# Certificate of Appropriateness

<b>Property</b>	1039 W. Mitchell St.	Historic Mitchell Street
<b>Description of work</b>	Replace existing ATM in same location on the 11 <sup>th</sup> St. façade with a larger unit that is accessible to persons with disabilities.	
<b>Date issued</b>	6/13/2019	PTS ID 114705 COA: ATM replacement

**PROPOSED BAY ELEVATION**

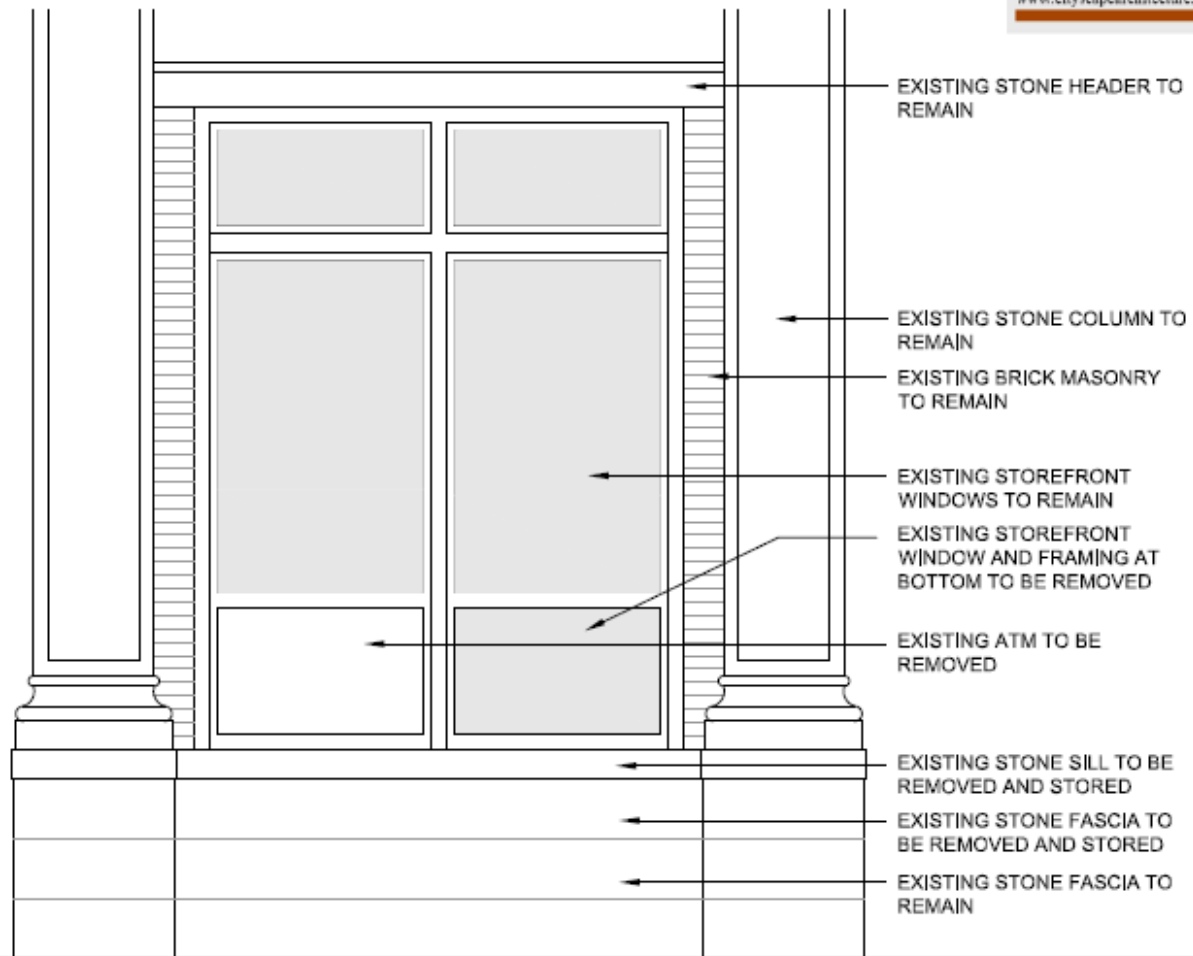
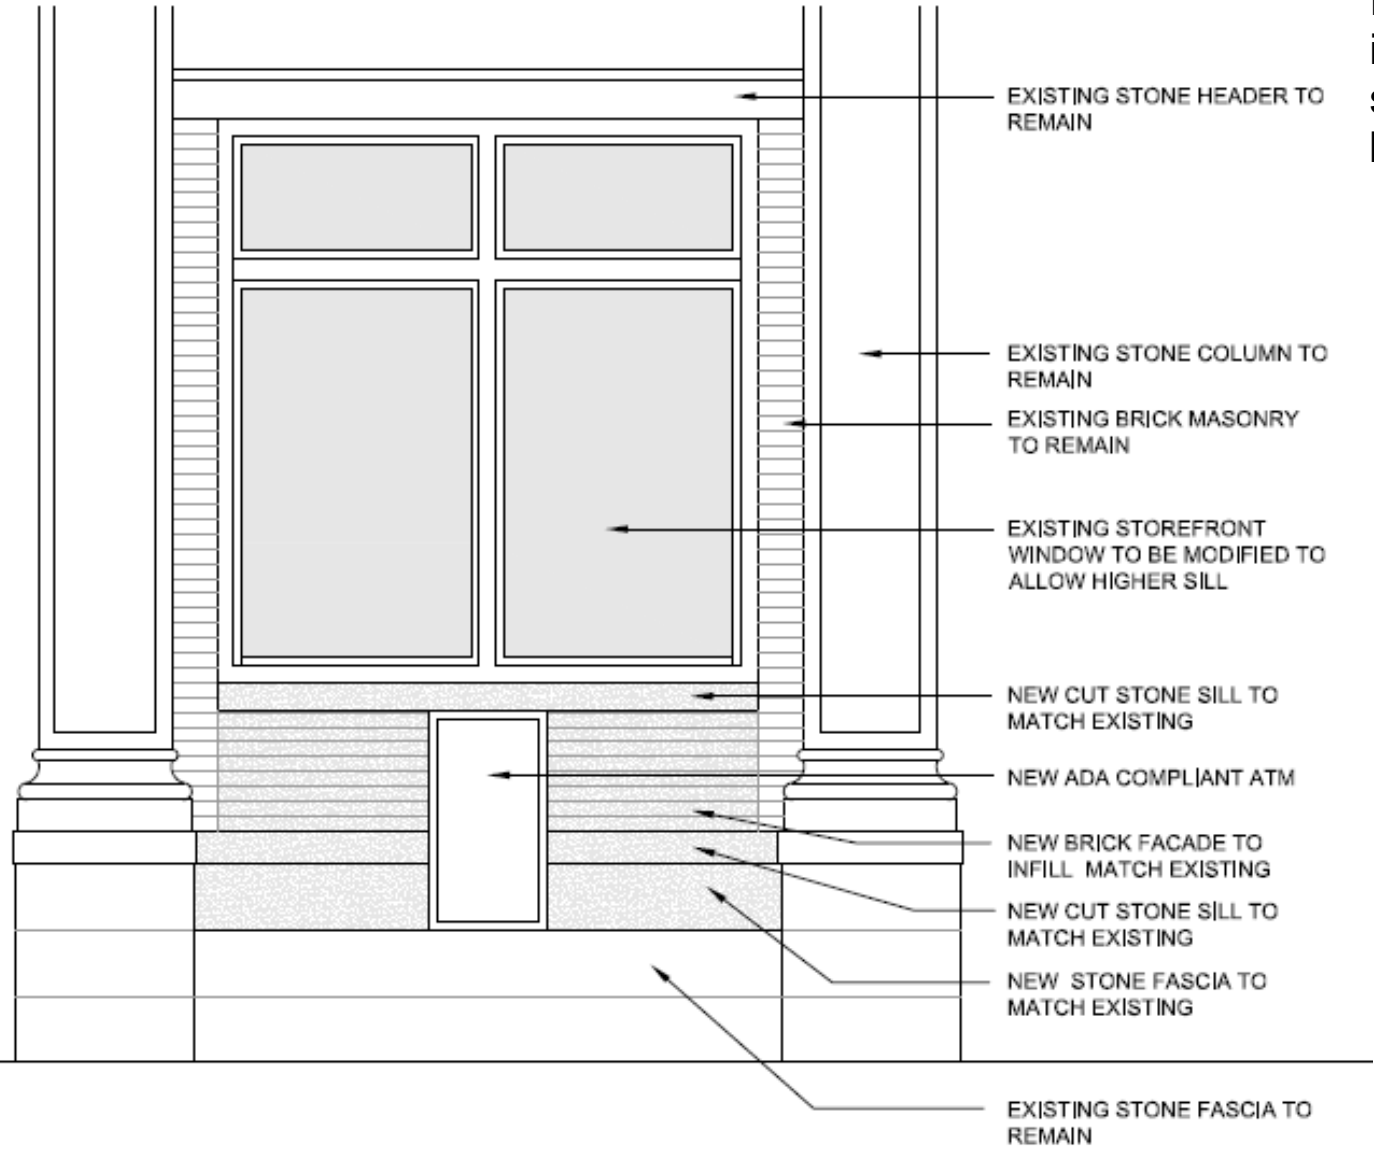
In accordance with the provisions of Section 320-21 (11) and (12) of the Milwaukee Code of Ordinances, the Milwaukee Historic Preservation Commission has issued a certificate of appropriateness for the work listed above. The work was found to be consistent with preservation guidelines. The following conditions apply to this certificate of appropriateness:

**New mortar must match the original mortar in terms of color, texture, grain size, joint width, and joint finish/profile. The compressive strength of the repointing mortar shall be equal or less than the compressive strength of the original mortar and surrounding brick or stone. The replacement mortar shall contain approximately the same ingredient proportions of the original mortar. Mortar that is too hard is subject to premature failure and could damage the masonry. See the city's books *As Good As New* or *Good for Business*, Masonry Chapters, for more information. In most cases, this means a lime mortar with natural hydraulic cement rather than Portland cement. No joint of a width less than 3/8" may be cleaned of damaged/decomposed mortar with power disc grinders. No over-cutting of the joints is permitted. Remove decomposed mortar back into the wall 2.5 times the height of the joint before repointing.**

**New brick must match as closely as possible the color texture, size, and finish of the original brick.**

**A sample panel of brick and mortar must be reviewed and approved by HPC staff prior to general installation of the material. UNDER NO CIRCUMSTANCES SHALL UNPAINTED MASONRY BE PAINTED, BE GIVEN A WATERPROOFING TREATMENT, OR CLEANED BY ABRASIVE MEANS; THIS STATEMENT SUPERSEDES ANY OTHER WORDING IN THIS DOCUMENT INDICATING THE CONTRARY.**
